ADDENDUM NO. 1

HVAC RENOVATION PROJECT PHASE II

SAGE PARK MIDDLE SCHOOL
WINDSOR, CT

DRAWING NO.
ME-6

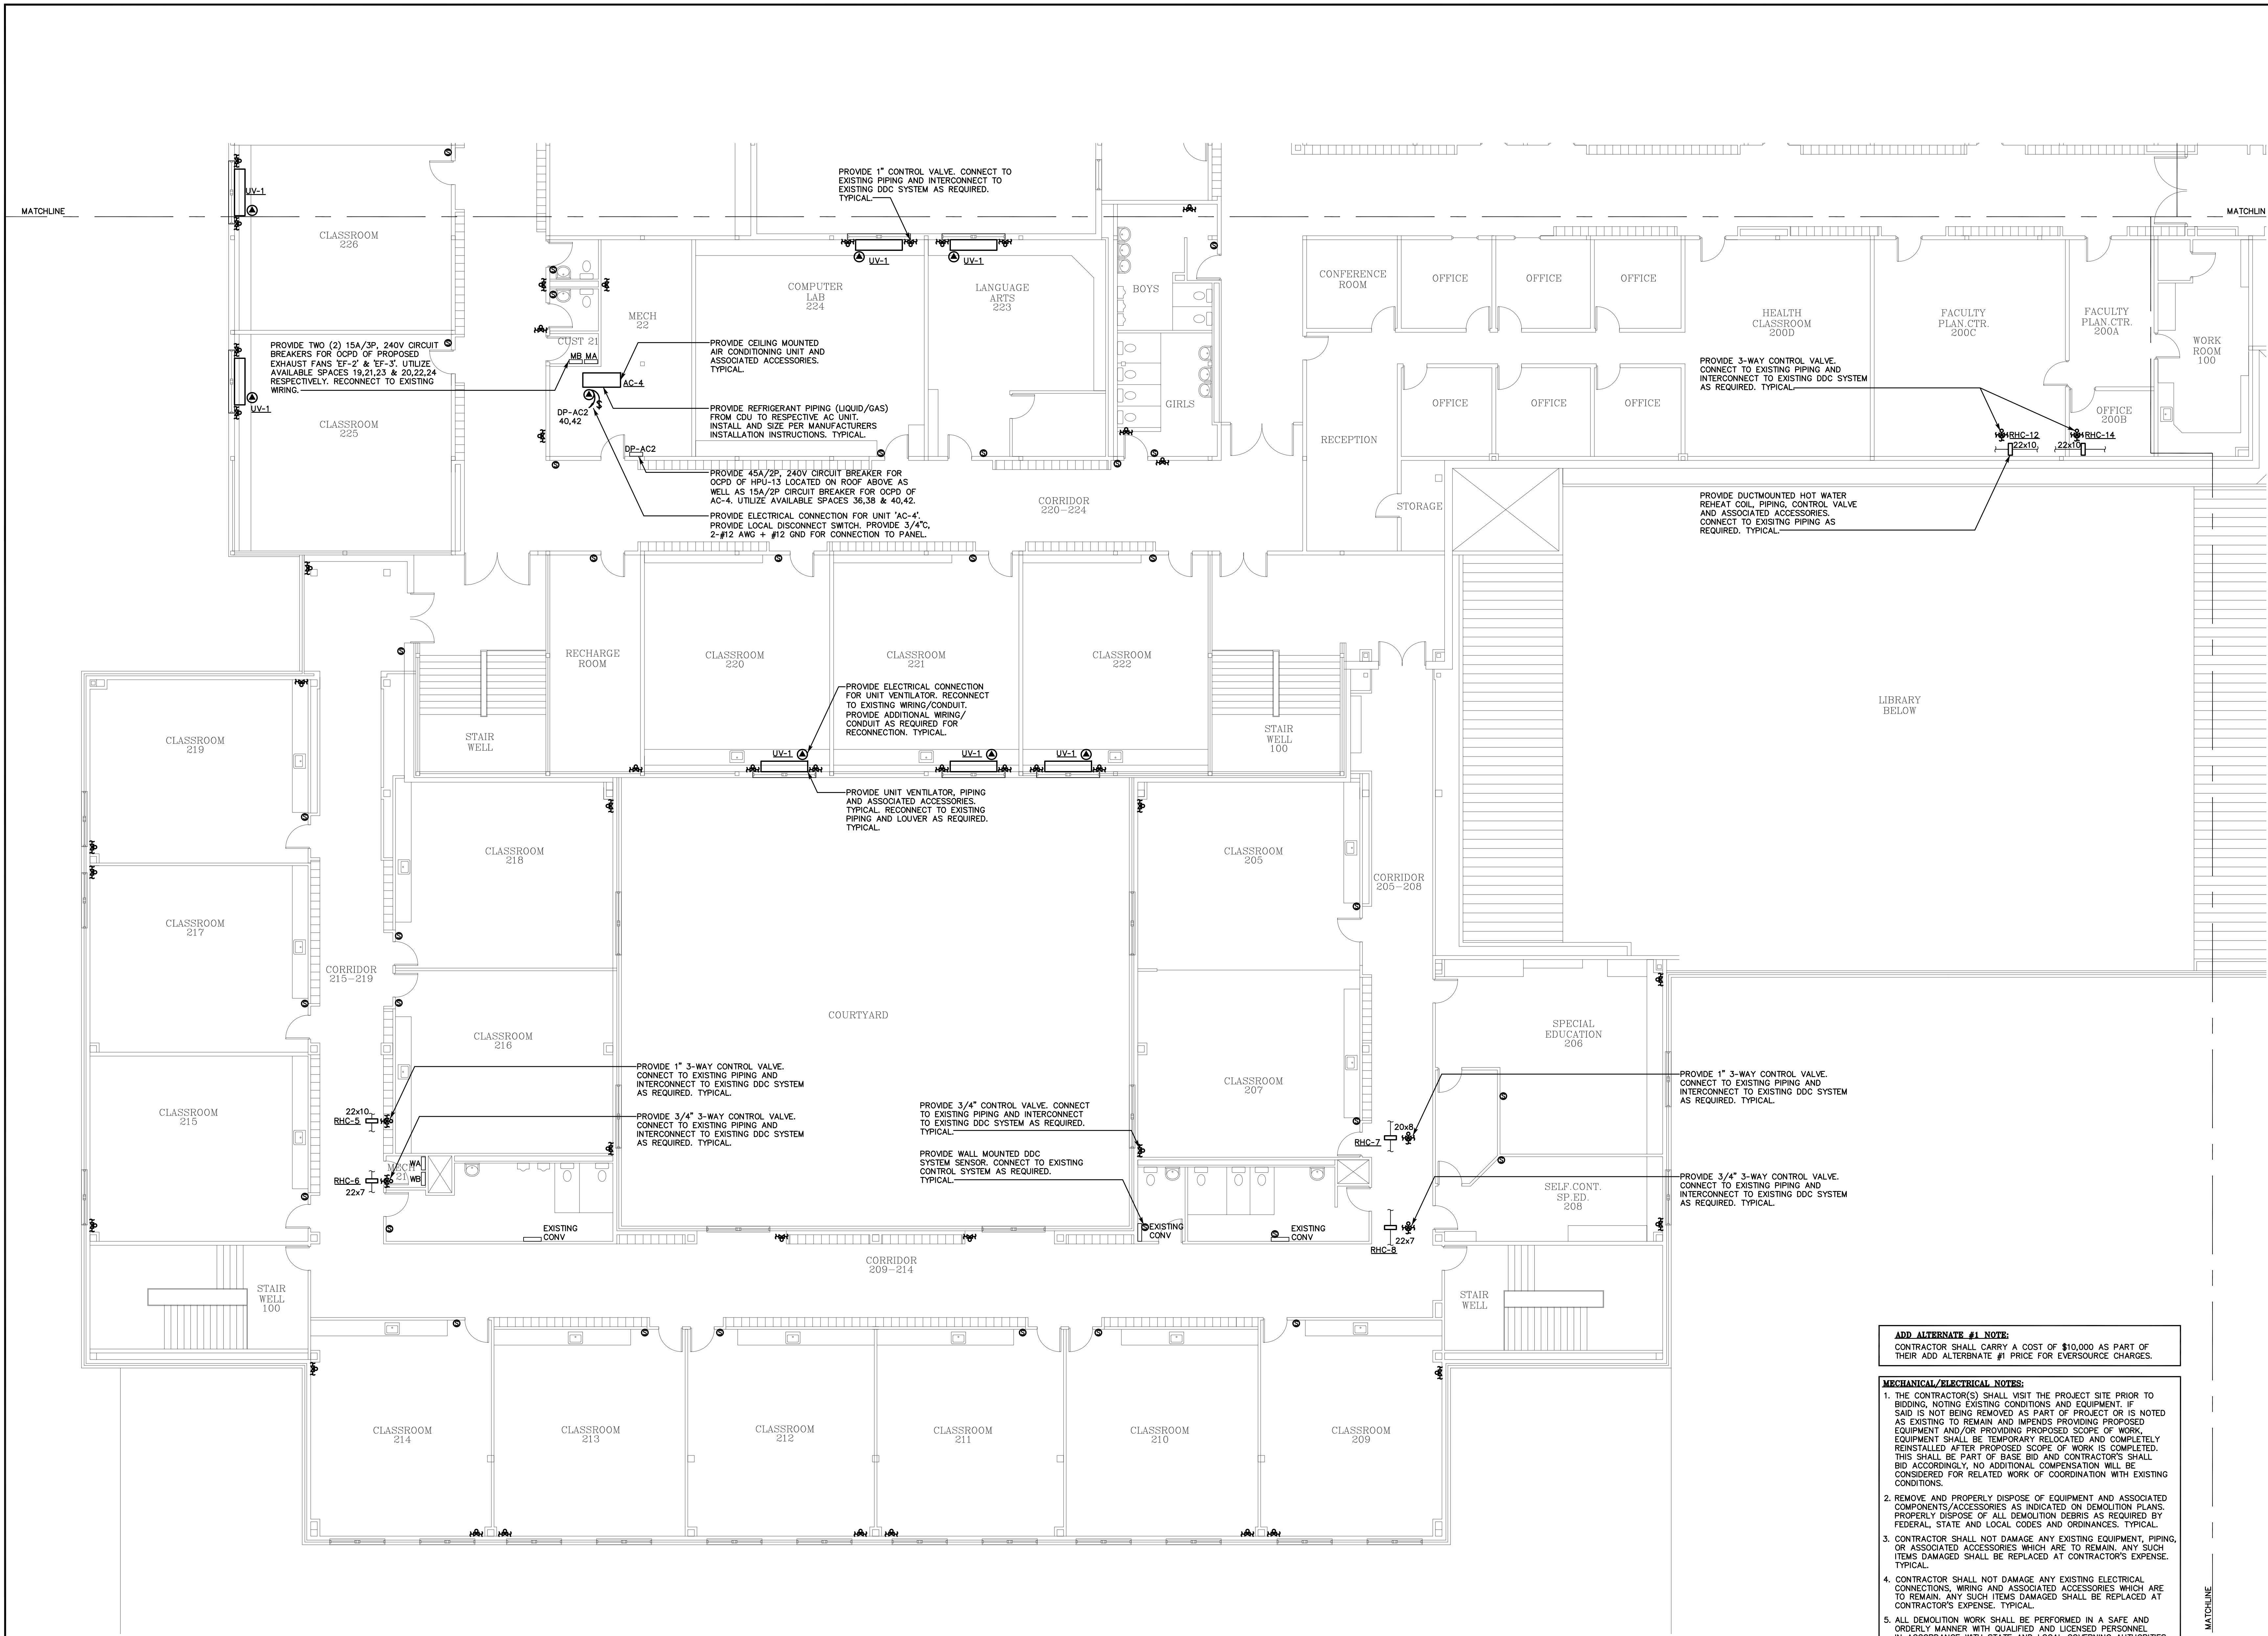
8. Drawing ME-3: Contractor shall provide a condensate pump and piping for AHU-1, AHU-S8 and AHU-S9. Pump shall be equal to little giant model VCMA-15ULS. Route condensate piping to nearest sanitary.
9. Remove drawings ME-6, ME-7 and ME-8.
10. Add drawings ME-6, ME-7 and ME-8 attached.
11. Specification Section 15870 Power Ventilators, 2.4 Centrifugal Roof Ventilators, E. Accessories: Remove 1. Disconnect Switch: Nonfusible type, with thermal overload protection mounted inside fan housing, factory-wired through an internal aluminum conduit. Provide fused disconnect as indicated on drawings.
